# Downtown Code Design Review Committee

## Meeting Minutes

March 5, 2020

#### 1) Sprocket Rocket Hub

Site Plan

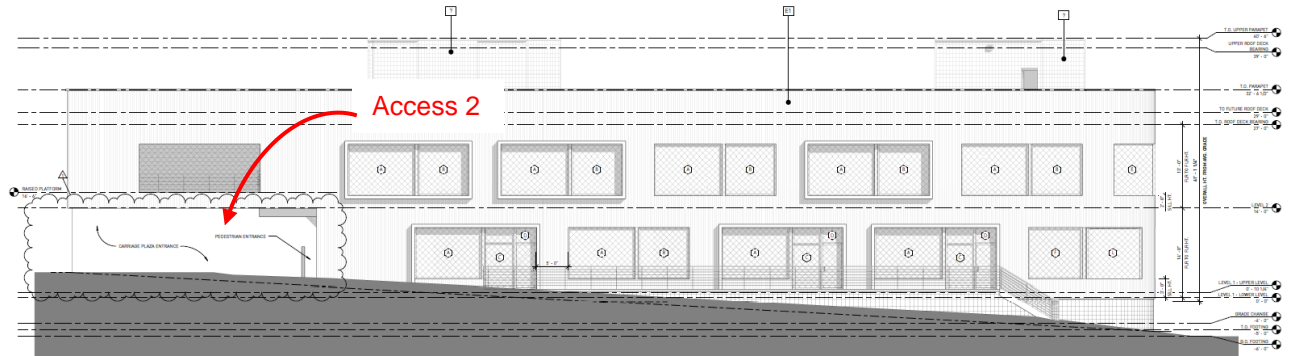
The Major and Collector Street Plan calls for a sidewalk corridor of 14-ft to include a 4-ft furnishing zone (for street trees, plantings, light poles, etc.) and a 10-ft clear sidewalk for pedestrians, plus a 4-ft frontage zone to be used for outdoor seating, storefront signage, and the like.

The applicant is proposing a 13-ft sidewalk corridor to include a 13-ft sidewalk and ADA-compliant street tree grates in lieu of a linear planting strip. The ADA-compliant ramp, approximately 83-ft long, provides a level entrance point to the multiple storefronts along Lafayette Street.

Staff finds the modification to be warranted due to site constraints, provisions made for a walkable street, and a cohesive design. Due to the irregular shape of the lot, and underlying slope conditions, a ramp and stair are necessary to provide a level entrance for tenant spaces. In addition, the proposed entrance platform offers a cohesive entrance to the multiple storefronts along the building and delineates the frontage zone from the clear sidewalk. Finally, the ADA-compliant tree wells will allow a seamless and continues sidewalk corridor, mitigating any conflicts with the flow of pedestrians.

1. Continue working with Planning staff on material of fencing and/or screening of access drive along Lafayette Street. No chain-link fencing is permitted per the DTC.
2. Revise landscape and civil site plans to show street trees within ADA-compliant tree grates in lieu of linear planting strip.

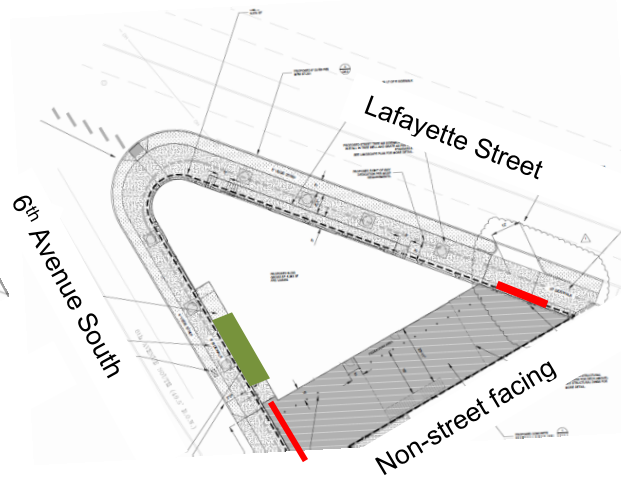
The ground floor level has been redesigned so that the majority of frontage is an active use with several tenant spaces and entrances. In the spirit of the Downtown Code to promote the notion of form over use, Planning staff finds it reasonable to consider a modification to allow a non-active use for a small portion of the building. The portion of frontage that is non-active has been designed in such a way that it appears similar to other uses in the building and may be adapted to alternate uses in the future. This portion of building without active use is recessed from the street, and an amenity area is provided to further activate the street.

**Plan illustrating movement of slow-moving vehicles**

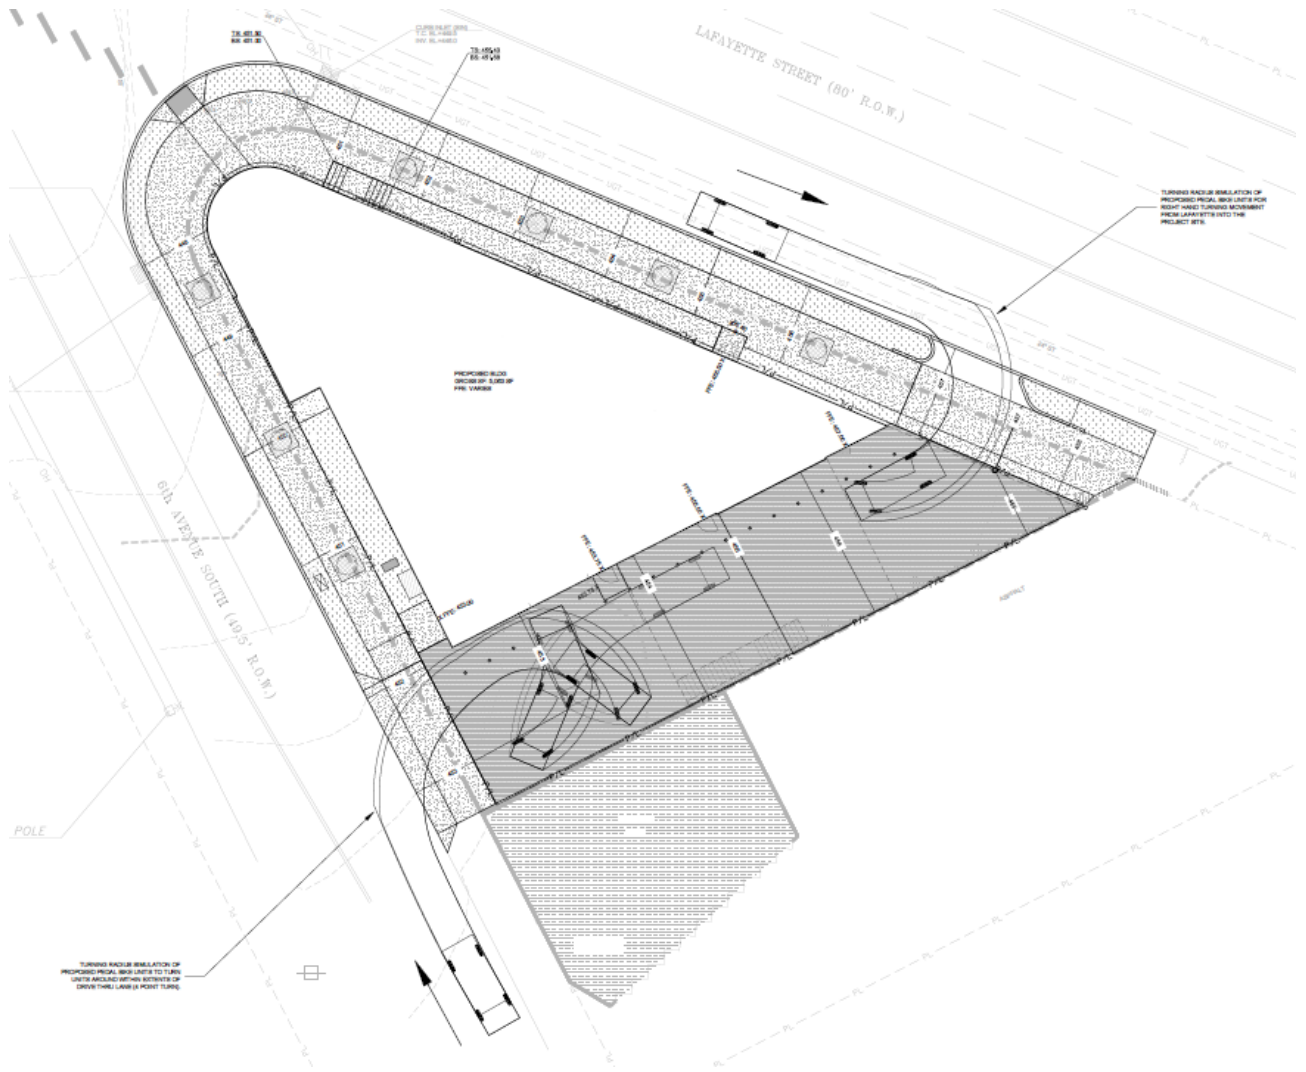
Given the complicated and challenging condition of the intersection at Lafayette Street, 6<sup>th</sup> Avenue South, Ewing Avenue, and Lea Avenue, Public Works prefers access to occur on 6<sup>th</sup> Avenue South at the signalized intersection. The frequent turning of slow-moving vehicles onto Lafayette Street, which is a 6-lane state road, is not ideal and would present a challenge for traffic flow. Further, the Downtown Code emphasizes the need to mitigate conflicts between pedestrians and vehicular traffic by reducing the number of curb cuts where possible and encourages access points to not occur along primary streets (Lafayette).

The applicant has provided diagrams that illustrate turning maneuvers of the slow-moving vehicles. The diagrams show operation of vehicles accessed from Lafayette, turning radius of vehicles within the site, and egress of vehicles to 6<sup>th</sup> Avenue South. While not ideal, the access point along Lafayette has been designed in such a way so that slow-moving vehicles would operate via a right turn in only from Lafayette Street. The design would prevent egress of vehicles exiting onto Lafayette and reduce the overall number of vehicles crossing the sidewalk.

**Figure 7: Ground Floor Plan with Landscaping, Encroachments, and Sidewalk Widths**

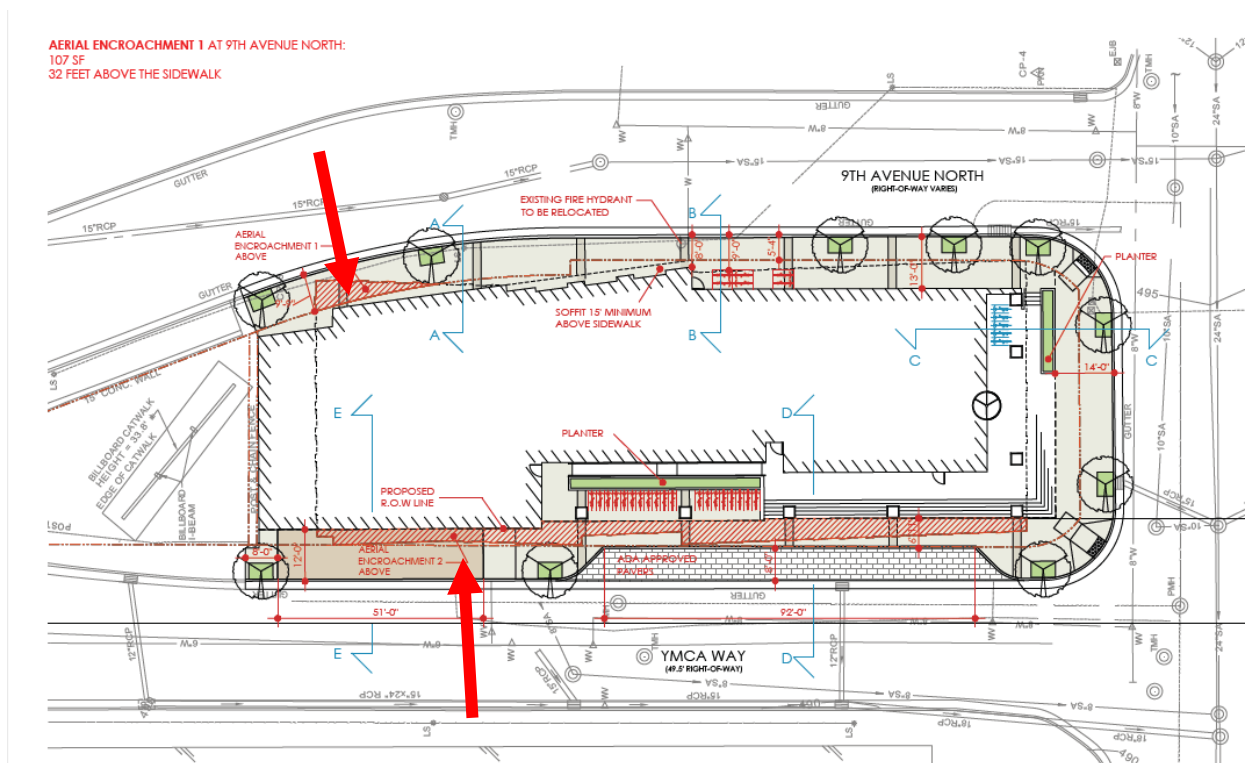
The required build-to zones along both 9<sup>th</sup> Avenue North and YMCA Way are 0-10 feet from back of the public sidewalk or pedestrian easement for 80% of the lot frontage. This building proposes to cantilever over portions of the sidewalk corridor beyond this build-to zone.

The encroachment along 9<sup>th</sup> Avenue North occurs towards the northern end of the façade, where the viaduct and property line begins to curve. The building's floor plates are generally rectangular, and a corner of that rectangle protrudes 32 feet above the grade of the sidewalk below. The encroachment does not impede the sidewalk corridor and allows the modular rhythm of the architecture to continue on this façade.

The encroachment along YMCA Way occurs along the entire length of the façade at 24 feet above the grade of the sidewalk corridor. The stated purpose of this request is also to allow the architectural movement of the façade. To compensate for encroachment into the pedestrian realm, the ground floor lobby of the building is recessed, visually opening that space and decreasing the impact of the encroachment. A mandatory referral is required for all encroachments and staff recommends that any approval of this modification be conditioned on the future approval of a mandatory referral.

The MCSP calls for an 8' sidewalk with a 4' furnishing zone along 9<sup>th</sup> Avenue North. These proposed widths are typical of secondary and tertiary streets Downtown. However, 9<sup>th</sup> Avenue North is a viaduct for a portion of this frontage and any additions to the sidewalk corridor will need to be joined to the viaduct via an expansion joint or other apparatus. The applicant has proposed that for a portion of the sidewalk corridor affected by the viaduct, a minimum 8' sidewalk be provided, but that the furnishing zone be removed. This allows the preservation of the pedestrian experience in response to the viaduct condition. A portion of the publicly accessible bicycle parking required for the site is provided around this section. Due to the sidewalk constraints identified, careful coordination with the Transportation Planning division must occur to ensure facility selection and rack placement minimizes interference with the pedestrian realm.

The MCSP also calls for an 8' sidewalk with a 4' furnishing zone along YMCA Way. The proposed cross-section calls for a 6'-11" sidewalk with no furnishing zone for those portions that are affected by a proposed lay-by lane and full compliance for all portions not affected. The building has no on-site structured parking. If tenants own private vehicles, they are stored elsewhere, with an on-site valet used to retrieve vehicles. Both the width and topography of the site as well as required loading and refuse areas make other locations less optimal than the location proposed. Other potential locations are more disruptive to the sidewalk corridor than the solution proposed.

1. A mandatory referral for all elements encroaching into the right-of-way must be approved by Metro Council.
2. The applicant shall coordinate with the Transportation Division of the Planning Department to ensure bicycle rack placement minimizes disruption of the sidewalk corridor.
3. The modifications allowed are specific to the proposed design of the building, both in site plan and architecture. Staff shall assess any future changes to the architecture of the building and may require further review by the DTC DRC if changes are deemed substantial by staff.

Figure 8: Elevation - East

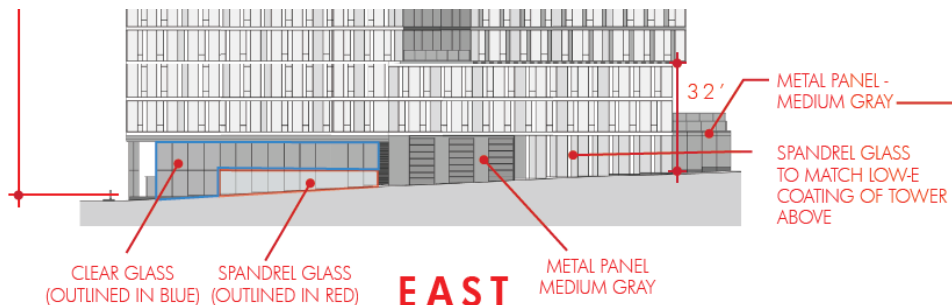
The DTC requires that all street level exterior windows have a minimum light transmission of 60%. A portion of the ground floor fenestration on the eastern façade features spandrel glass. This has been requested for privacy, as there is grade separation between the ground floor and the sidewalk, causing building occupants to be a few feet lower than passersby. The spandrel glass is in the same rhythm as the clear glass and only is proposed for areas substantially affected by the grade change. Other portions of this façade do feature spandrel glass as a façade material, but these areas are covering mechanical and egress areas and are not included in glazing calculations.
